09 - 2011
BTD141, BTD141Z, BTD141H2
18V IMPACT DRIVER KIT

SERVICE CHANGES

1. Changes on Hammer Case Cover and Bumper

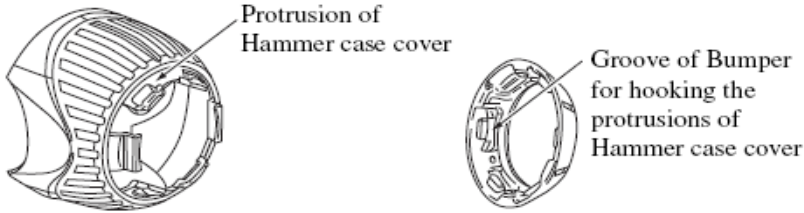
Item No.	Description	Type 1	Type 2
14	Bumper	424015-7	424369-2
15	Hammer Case Cover	450585-0	452409-6

Above parts are completely interchangeable as a set.

Type1: Bumper is hooked with the grooves of Hammer case.

Type2: Bumper is hooked with the protrusions of Hammer case cover as illustrated below.

2. Changes How to Assemble Carbon Brushes

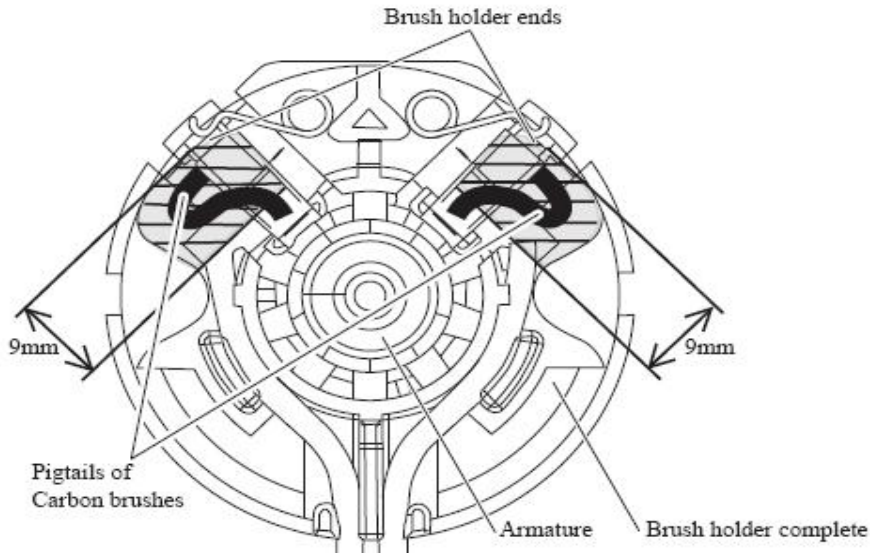
Item No.	Description	Type 1	Type 2
36	Carbon Brush	194427-5 (W/O ORIGIN)	195021-6 (W/ ORIGIN)

Do not protrude the pigtails of Carbon brushes from the specific spaces.
Refer to the following illustration.
